Your Comment on the Ohoka Residential Subdivision - FTA 231

SUBMISSION REGARDING THE PROPOSED
OHOKA DEVELOPMENT BY CARTER GROUP (FTA231)
COMMENTS ON PDP PREDICTED FLOODING LEVELS

Prepared by J Docherty
Date: 12/10/26
Status: R0

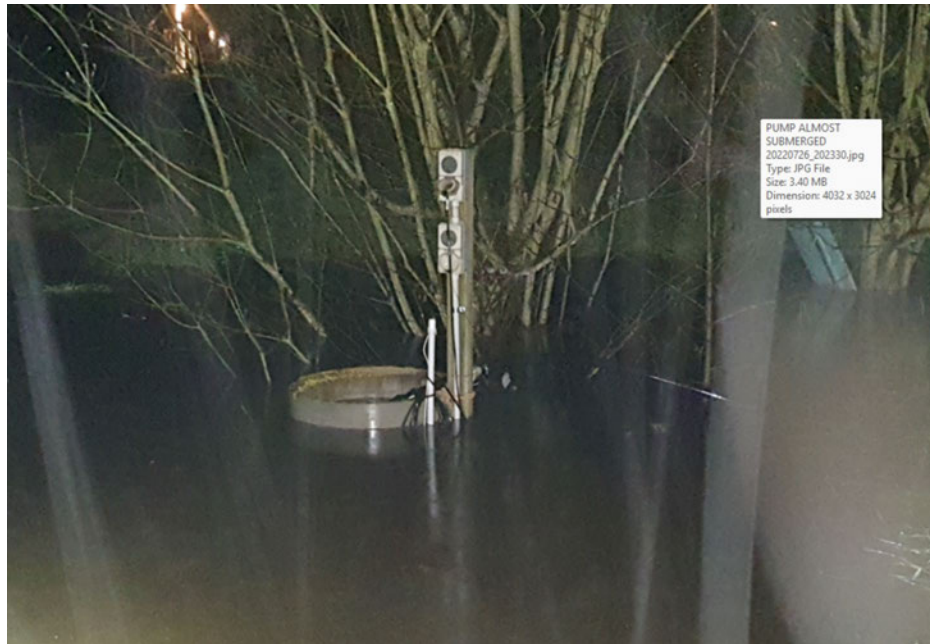
The following photo shows water on the 21st of July 2022, prior to the flooding event on the 25th & 27th of July. Prior to this rainfall had occurred on two occasions, with the total for July up until midnight on the 24th of July being 110mm. The last rainfall prior to this was a total of 26mm over 26 hours. Having this amount of water ponding before a flooding event exacerbates the flooding. This has not been taken into account in the modelling.

Figure 27. Difference between the downstream boundary normal depth slope of 0.005 and normal depth slope of 0.001.

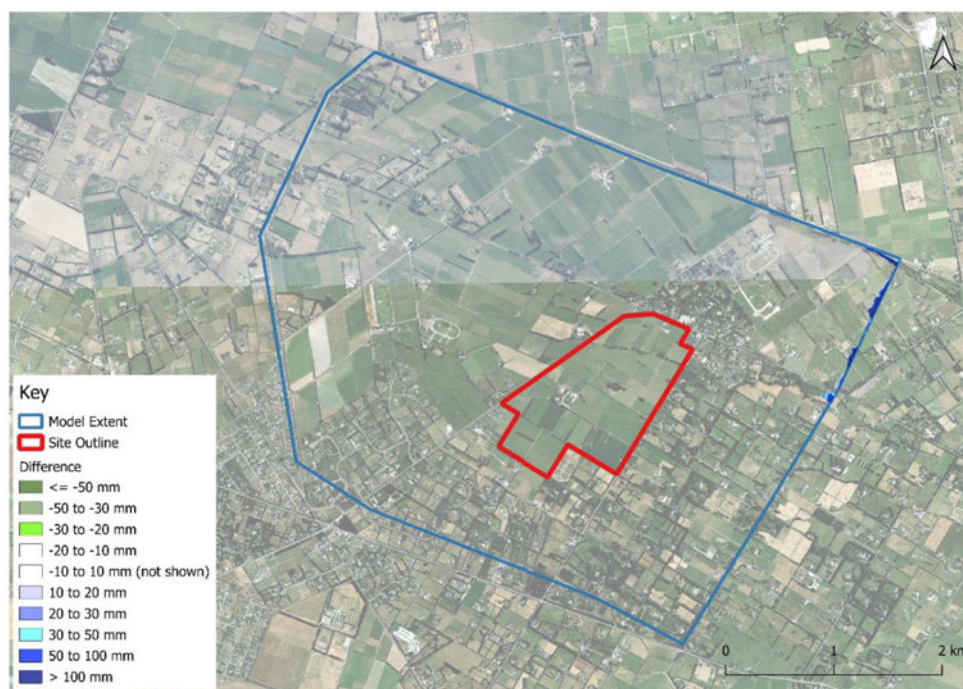
The latest report includes the following figure which indicates that there are no effects due to the boundary conditions. That defies logic. If the flow from the area is restricted the water levels inside the boundary must increase.

Figure A5, Post-development flood depths for the 200-year event with climate change (D02_200YR_Post). Depths less than 50mm not shown.

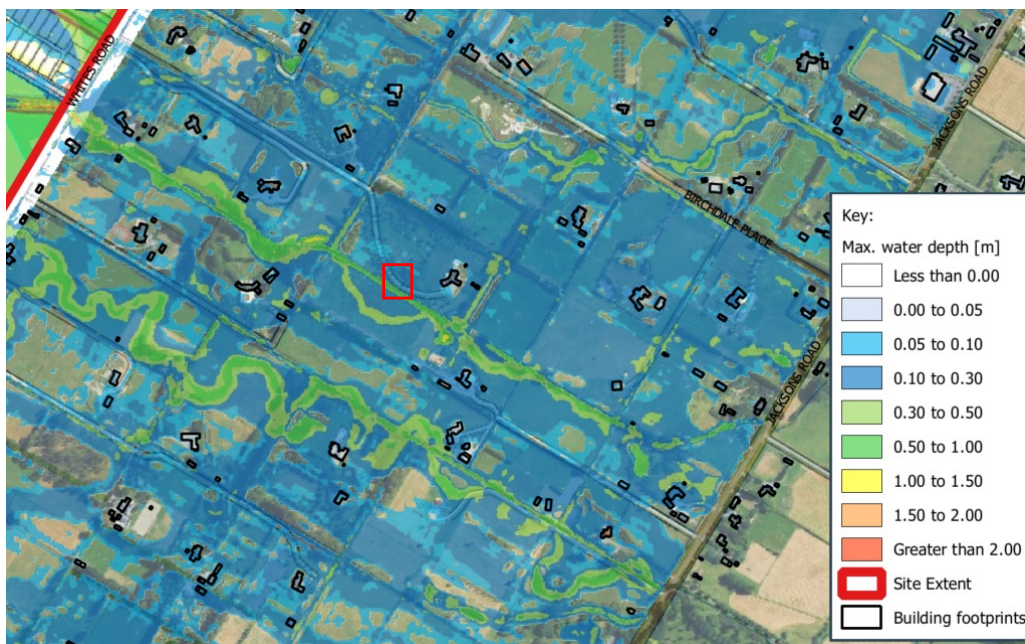
The following photos show flooding which occurred in June 2014. The bridge in this photo, which is submerged, is just behind the container that is visible, is **1100mm** above the bottom of the stream. PDP predict that the 200 year event will result in a depth between **500 and 1000mm**. (Refer to the figure below and the area in the red box.) This clearly shows the discrepancy between the model and reality.

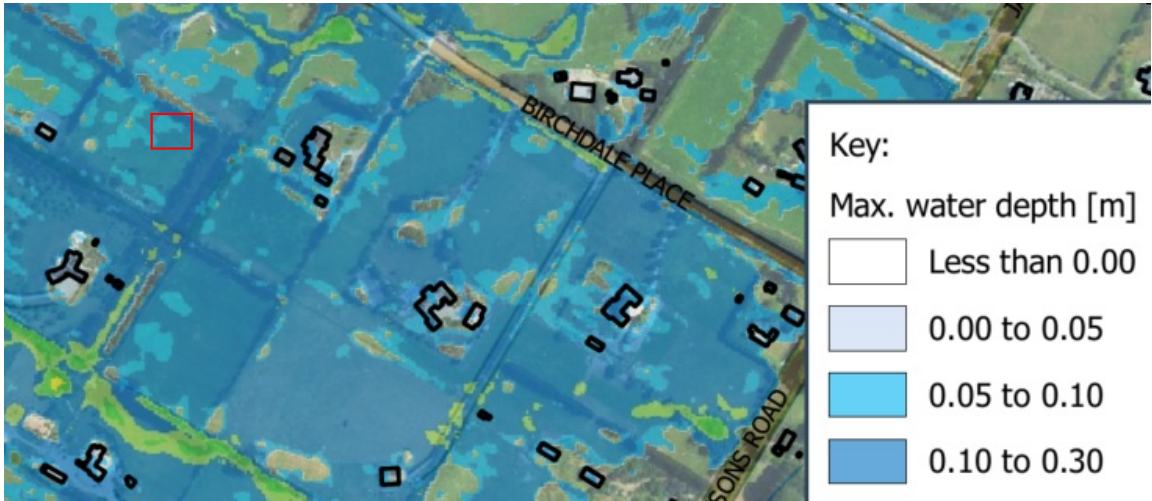
The following photo taken at [REDACTED] shows a water depth of about 65mm on the 26th of July 2022. The PDP prediction (red box) is for a depth of between 50 to 100mm during the 200 year event.
